Service Bulletin

Subject: KNOCKING / SQUEAKING NOISE FROM FRONT SHOCK ABSORBER, CREAK- ING NOISE FROM FRONT LOWER ARM BUSHING	Bulletin No: 02-010/16
	Last Issued: 10/10/2016

This bulletin supersedes the previously issued bulletin(s) listed below: The changes are noted in Red beside the change bars.

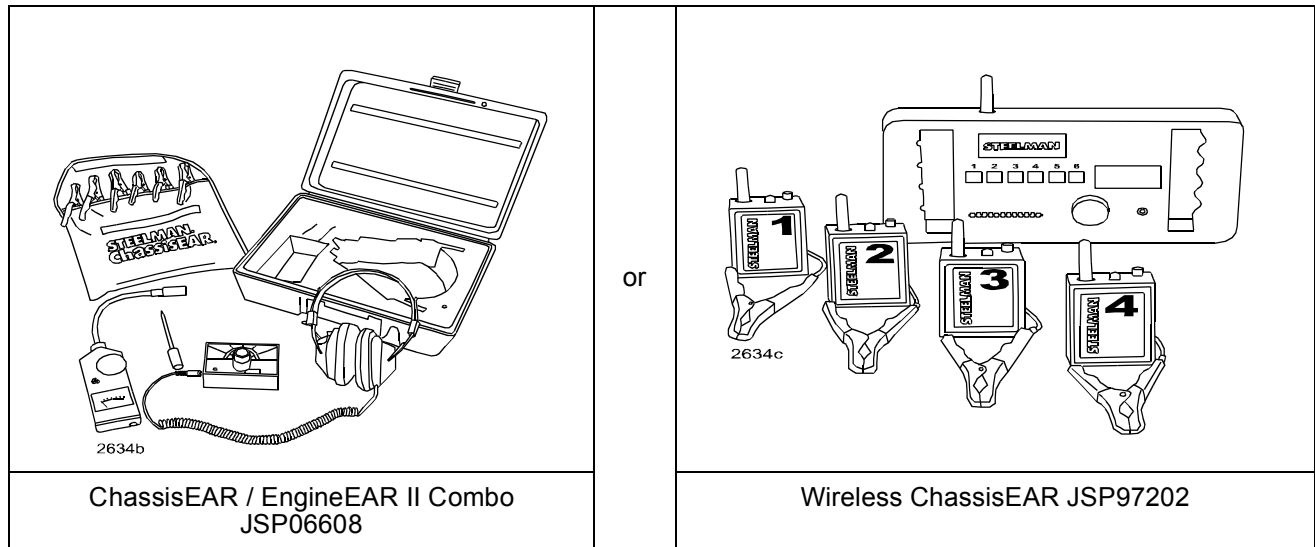
- upper front strut bearing (A) damage. (CX-5 and Mazda6)
- stick/slip between the front strut bearing and coil spring. (CX-3, CX-5 and Mazda6)
- the bump stopper (C) may be contacting the strut bearing when the front shock absorber is compressed, causing a popping noise. (Mazda6 only)
- The front lower arm bushing (D) is making a stick-slip noise in wet road conditions. (CX-5 and Mazda6)

1. The material and production method of the front strut bearing (A) has been changed. (CX-5 and Mazda6)
2. A protector has been installed onto the coil spring. (CX-5 and Mazda6)
3. The shape of the bump stopper (C) will be modified in the future. (Mazda6 only)
4. The shape of the coil spring has been changed. (CX-3 only)
5. Friction of the lower arm bushing has been reduced by adding a dry coating. (CX-5 and Mazda6)
